STANDARD DEPARTURE CHART-INSTRUMENT

RJFN / NYUTABARU

NIPPO SEVEN DEPARTURE

INSTRUMENT APPROACH CHART

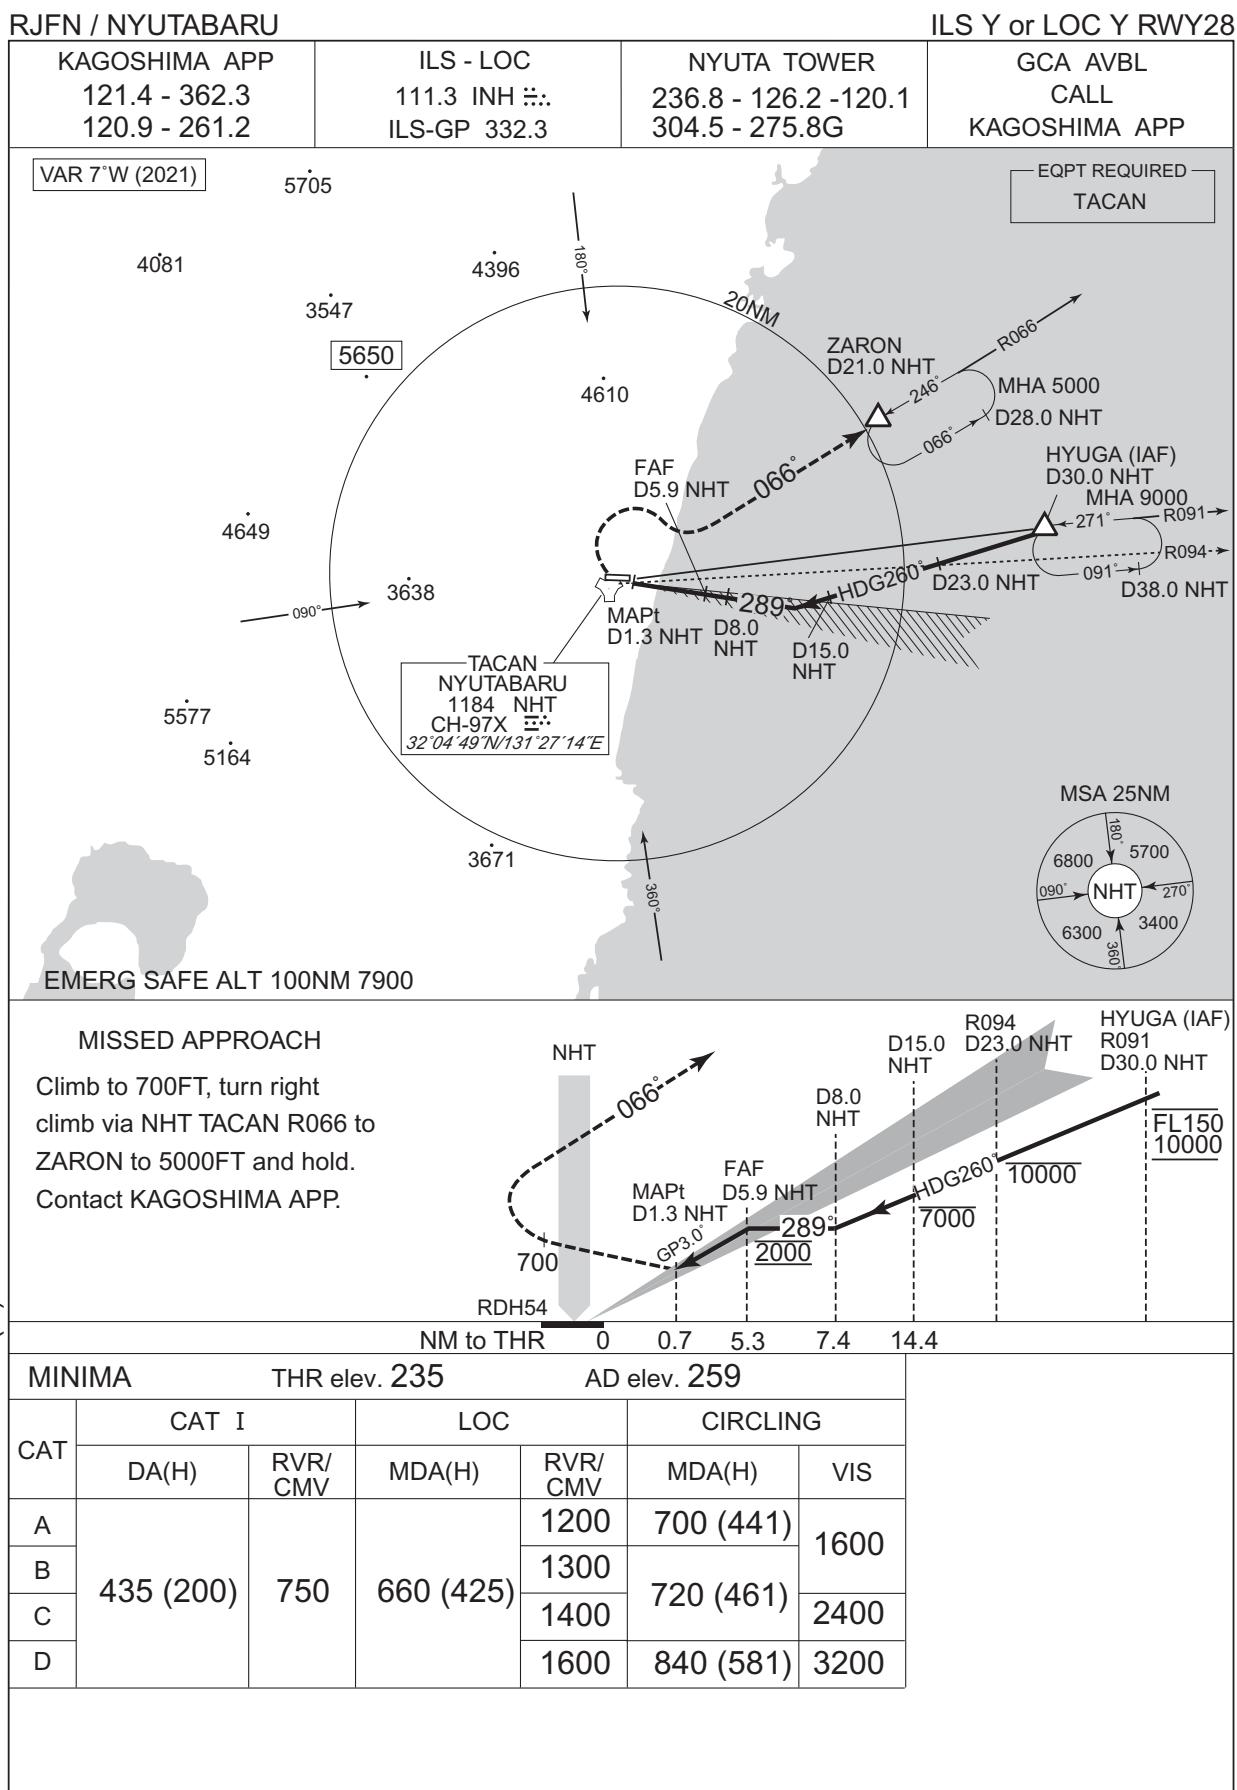
CHANGE : VAR, PROC renamed. EQPT REQUIRED added. PROC course. MISSED APPROACH course. MSA.
NM to THR added. MDA(H) for CIRCLING.
